HORSHAM DISTRICT COUNCIL CONSULTATION

TO:	Horsham District Council – Planning Dept
LOCATION:	Land East of Tilletts Lane Warnham
DESCRIPTION:	Erection of 59 dwellings with associated open space, landscaping, parking, access, and drainage infrastructure.
REFERENCE:	DC/25/1155
RECOMMENDATION:	Holding objection / Modification / More Information

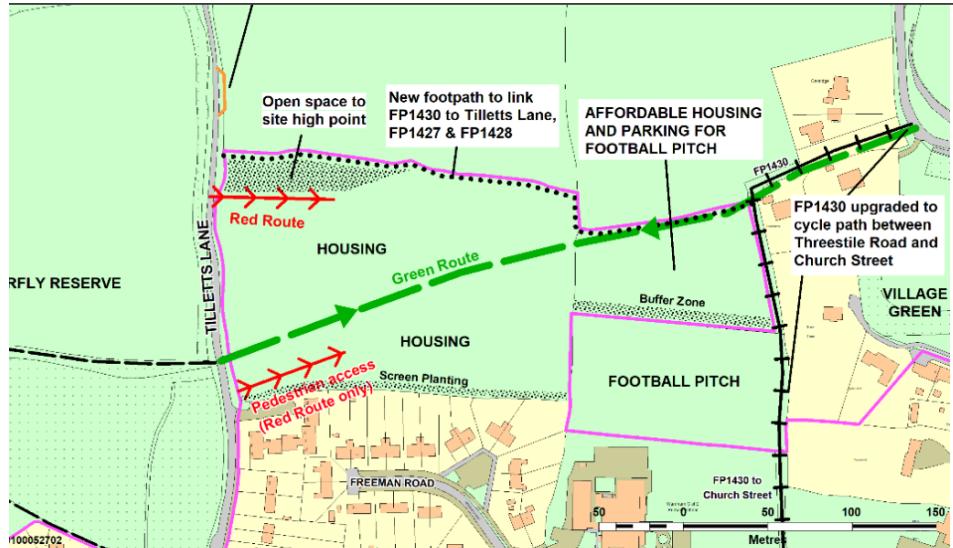
While some positive changes have been made to address landscape concerns highlighted within pre-application advice, there remains several issues that are discussed in detail below. Further consideration of the layout, particularly within the northeastern parcel of the site, needs to be given in order to successfully mitigate identified residual adverse landscape and visual effects.

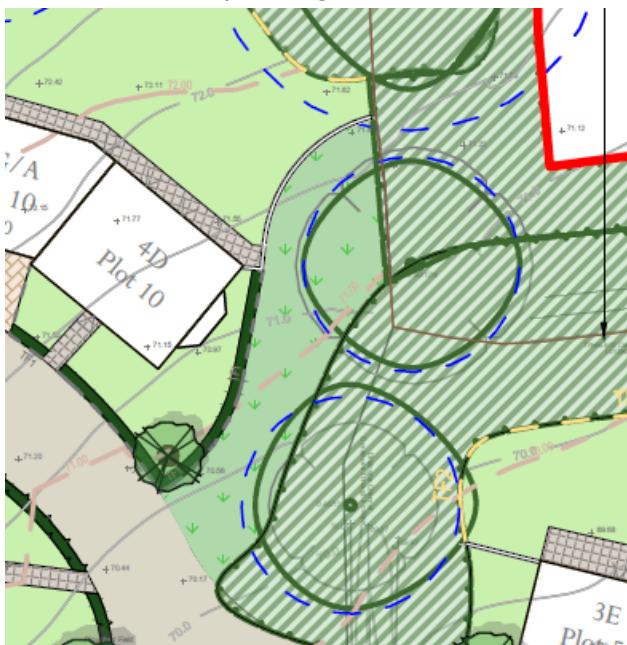
11. Street trees are particularly lacking within the southern access road. The street tree

planting strategy overall needs reviewing as many trees are within private gardens and their retention will be difficult to control. Due to the relationship with the proposed dwelling, the trees shown in the extract below would be highly likely to be removed by a future occupier.
